Subject: Juniper Ridge Landfill Expansion Application, MEDEP #S-020700-WD-BI-N Follow-up to Department Staff's Responses to the March 4, 2016 Submittal on Staff's Review Comments as Presented in the Department's April 5, 2016 Letter

## EXHIBIT D

### **BGS AND NEWSME'S RESPONSE TO MEDEP'S APRIL 1, 2016 TECHNICAL MEMORANDA**

PW-08-03  
26.5-HOUR PUMP TEST  
FEBRUARY 5, 2009 TO FEBRUARY 6, 2009  
AVERAGE 8 gpm  
176.14 FEET OF DRAWDOWN

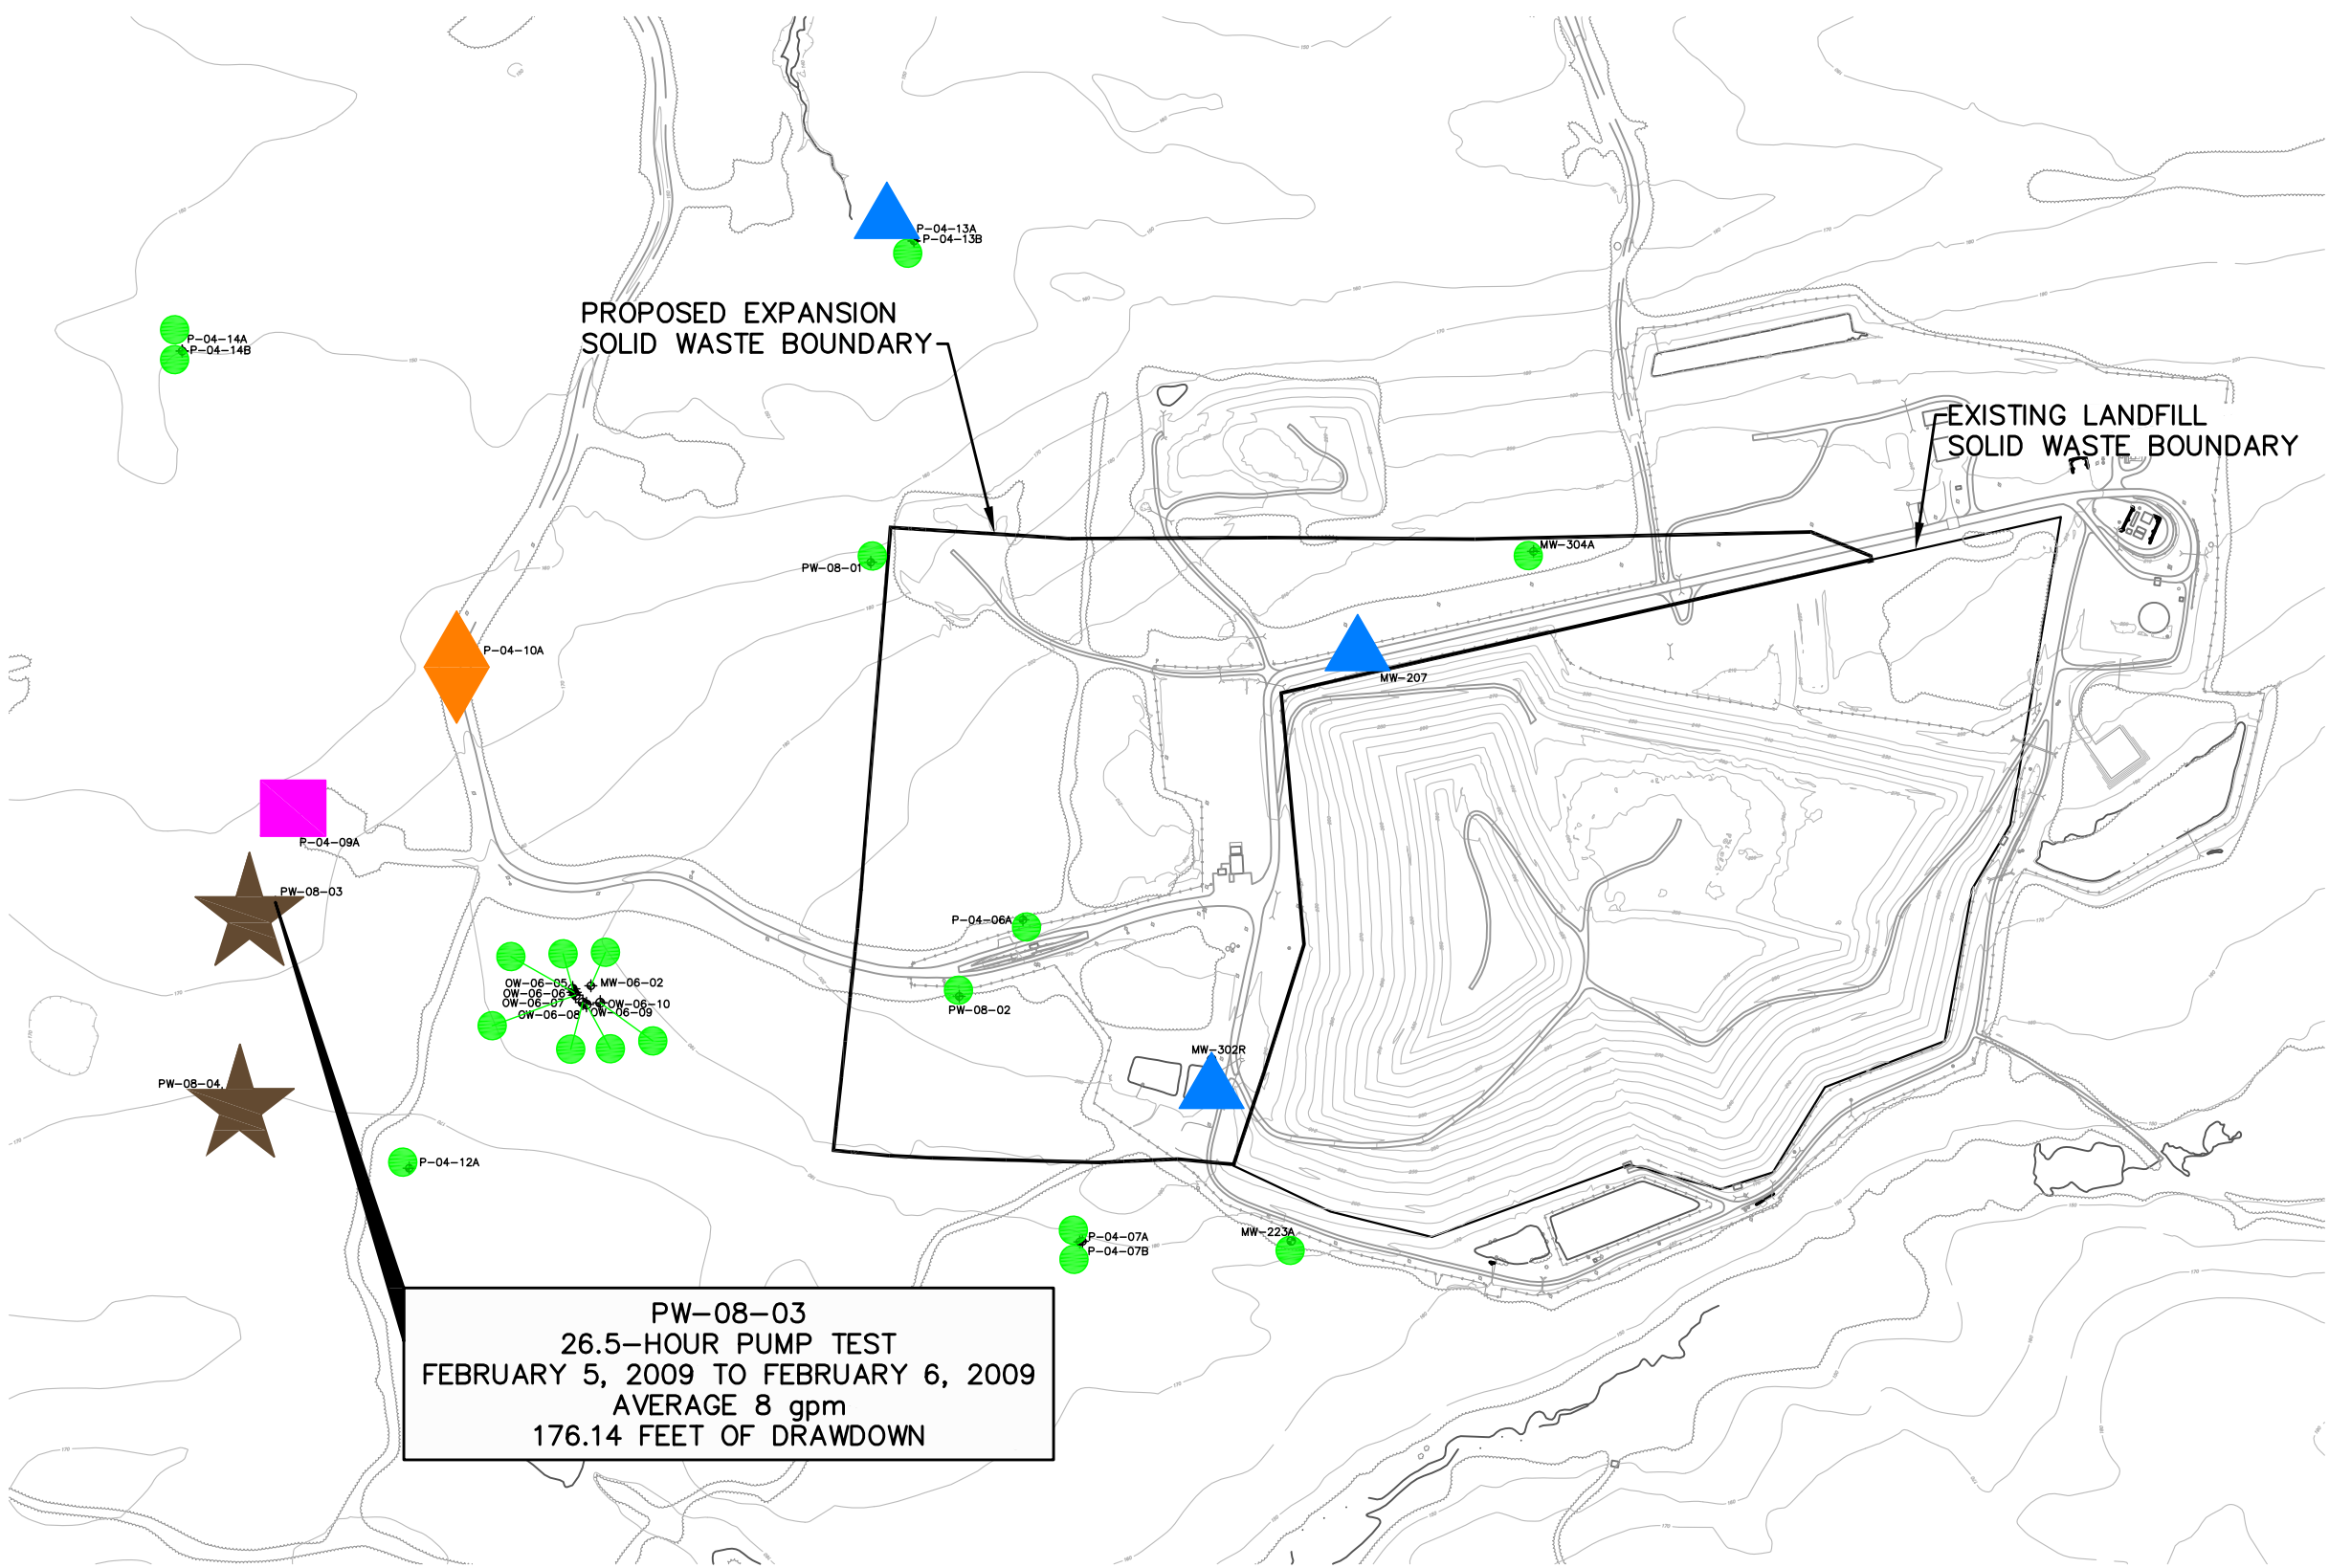
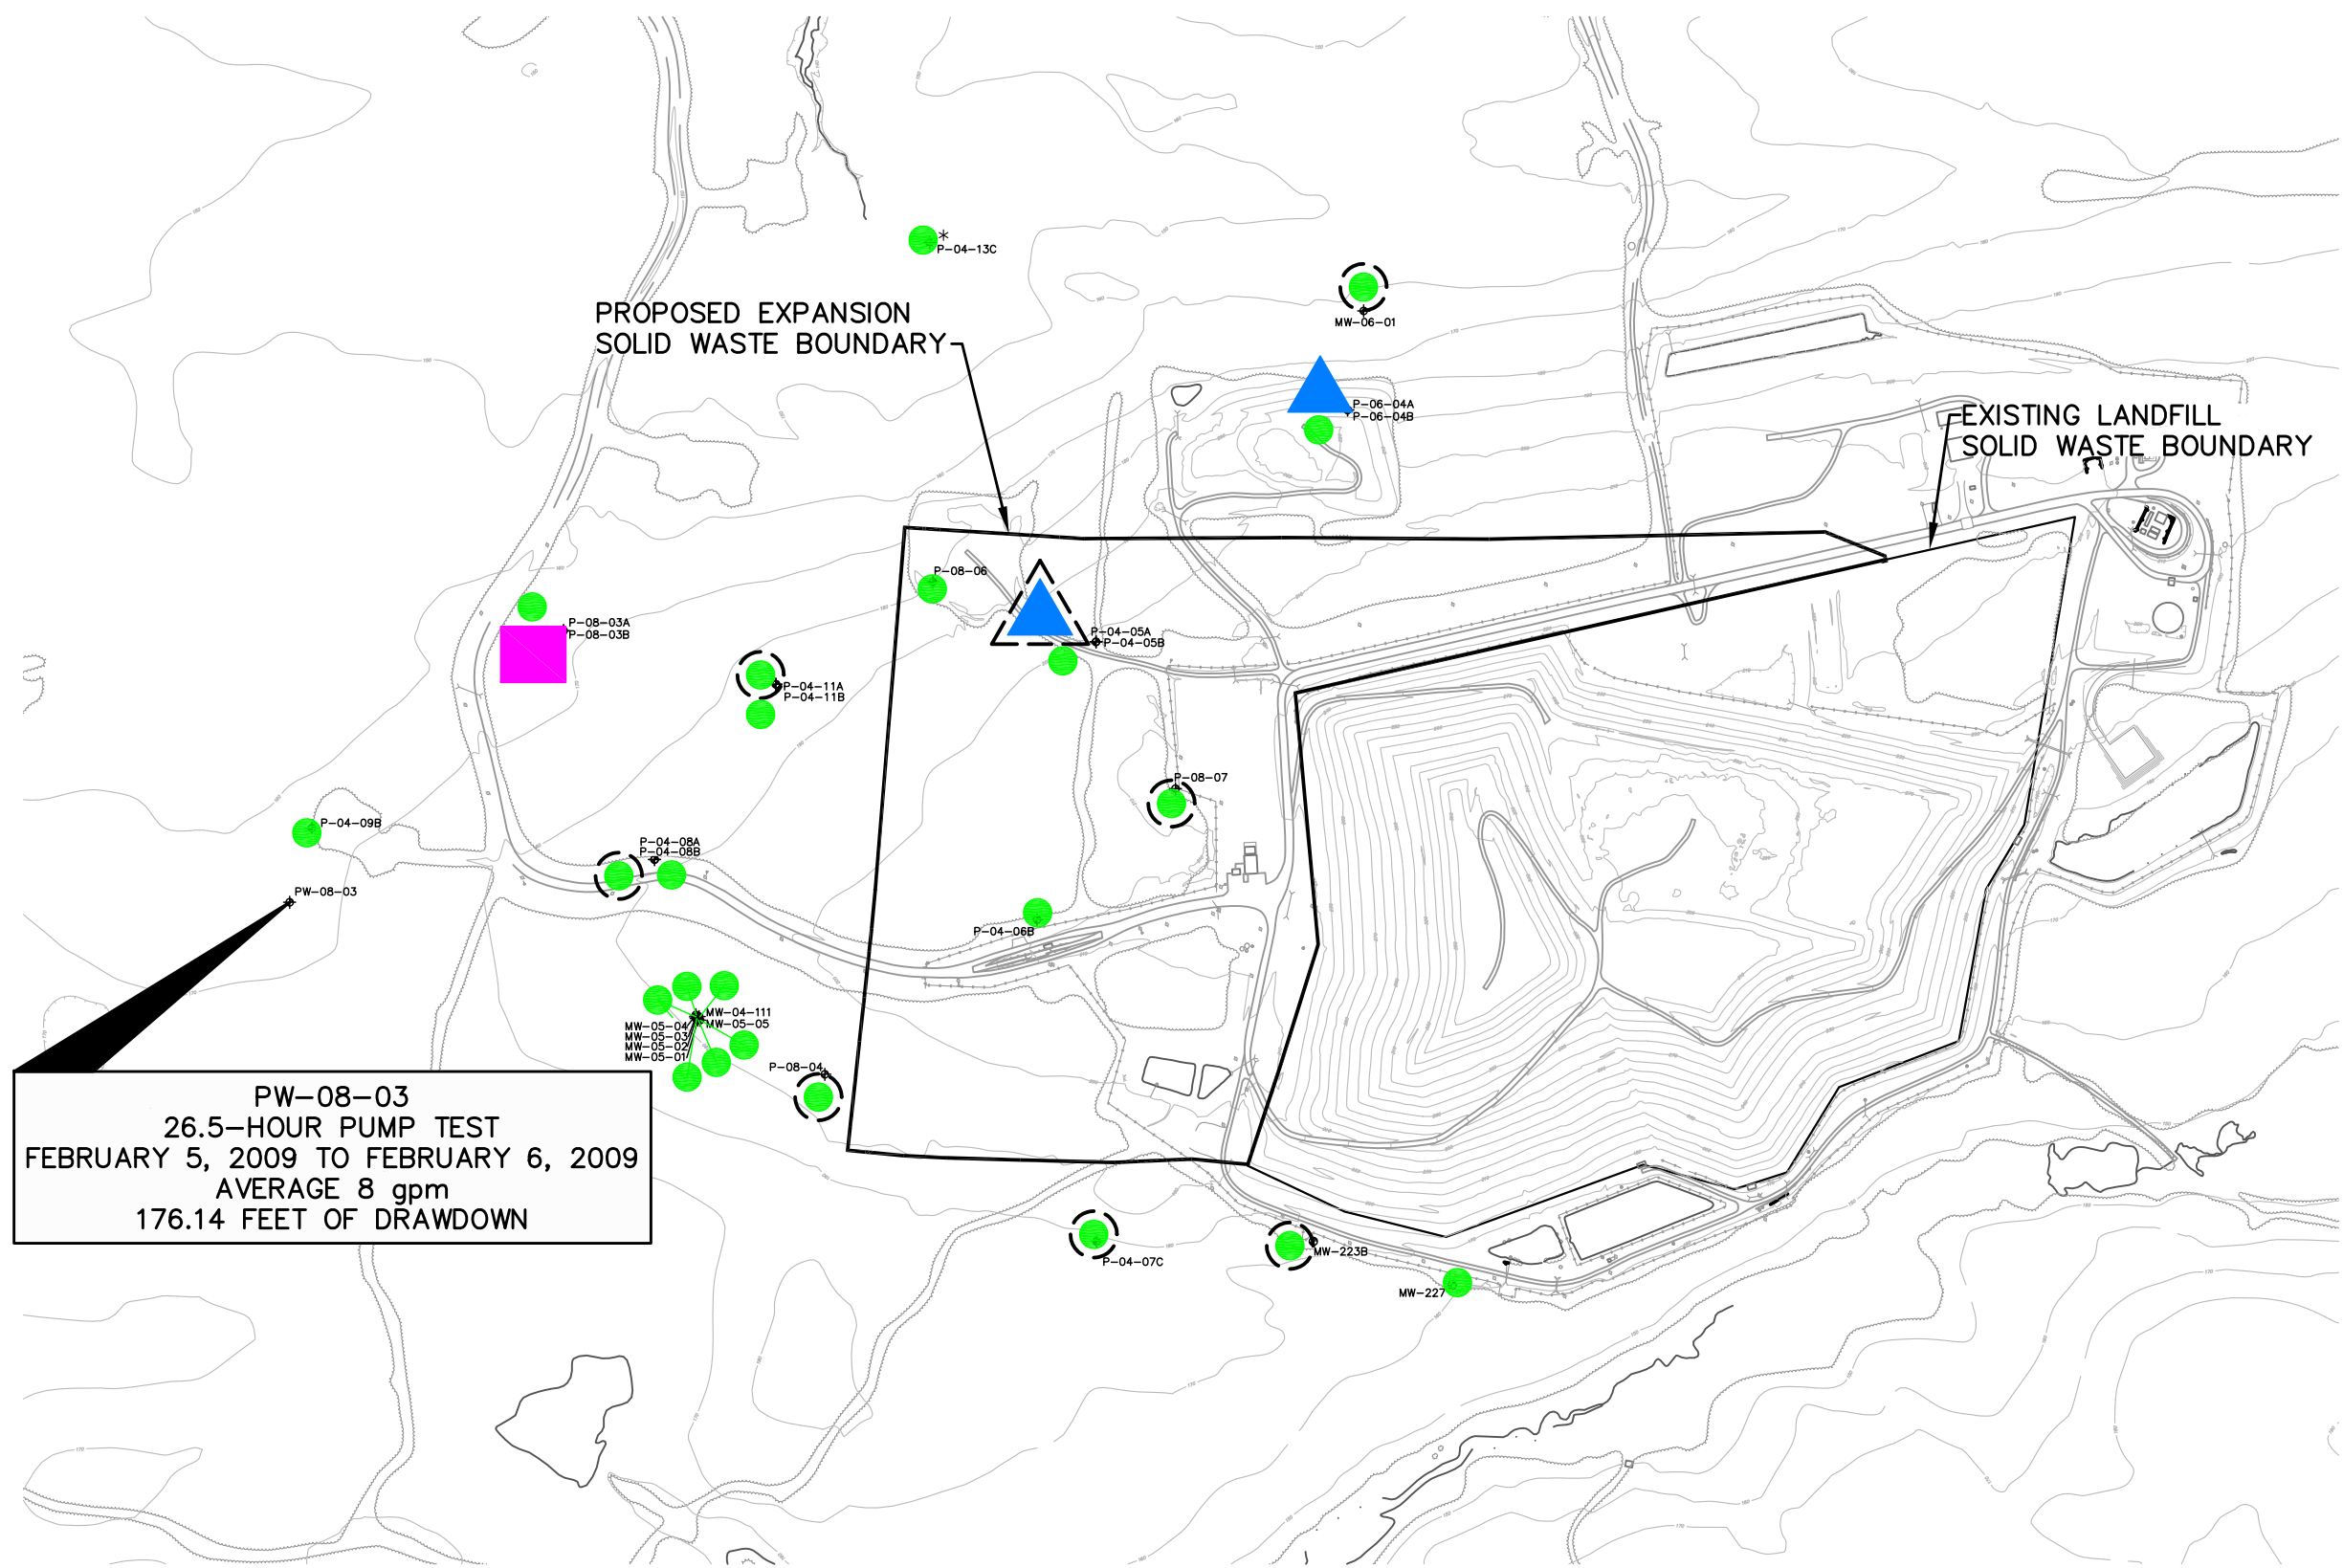
**MEDEP Follow-on Response: My original comment included a request for figures to illustrate the observed drawdowns in monitoring wells screened in the till. JRL's**

response did not include the requested figures. I continue to assert that a graphic depiction of locations where the till is hydraulically connected to the underlying bedrock is important and may assist in locating wells for long term monitoring and extraction wells in the unlikely event a significant leachate release were to occur.

**MEDEP – Follow-on Response:** JRL's response to my comments about Figures U-14 and U-15 do not adequately address my comments. Additional figures are needed to properly illustrate the data collected during each of the five pumping tests. To further enhance the results of the pumping test data, it is necessary to include all of the drawdown data obtained during each test. Again, I contend it is important to differentiate between bedrock and till wells. As an example, the figure (Figure U-14) illustrating the 26.5 hour pumping test performed on PW-08-04, uses graduated symbols to depict the range of observed drawdowns for only 20 of the 53 wells where water levels were observed. There are also apparent inaccuracies on the existing figures. The text on page 26 states six wells (5 bedrock and 1 till) experienced between 0.1 and 1.0 foot of drawdown although Figure U-14 only depicts three wells in this range. The figure (Figure U-15) depicting the drawdowns observed during the long-term pumping tests at PW-08-01 and PW-08-02 also requires revisions as only a fraction of the drawdown data is depicted on this figure. Although JRL collected drawdown data for 53 wells during the tests, Figure U-15 only depicts data for 21 wells.

To address these comments, I recommend JRL display all of the drawdown data for each pumping test on appropriately scaled figures. I also ask JRL to augment the drawdown data included in Appendix M with a table summarizing the total drawdown observed in all wells during each of the pumping tests. This table would include those wells instrumented with pressure traducers and those where manual water levels were made. I am certain JRL has previously compiled this data to complete the pumping tests analyses. I also request that JRL also provide the Department with an electronic copy of the spreadsheet.

Applicants' Response: Included in Attachment SME-D3 are ten figures augmenting Figures U-14 and U-15 included in Appendix U of Volume II of the Application. These figures show monitoring wells and piezometers where drawdowns were measured during the pumping tests. For each pumping test two figures, one showing the drawdown in the bedrock, and one showing the drawdown in the till, have been prepared. On the figures showing the drawdowns in the till the locations where the instrument screen is located within five feet of the bedrock surface are identified.

Applicants' Response: See previous response to the comment regarding Appendix U, Pg 25, 5.0 Pump Test Proof of Bedrock Interconnectivity. The augmented U-14 and U-15 figures are contained in Attachment SME-D3.
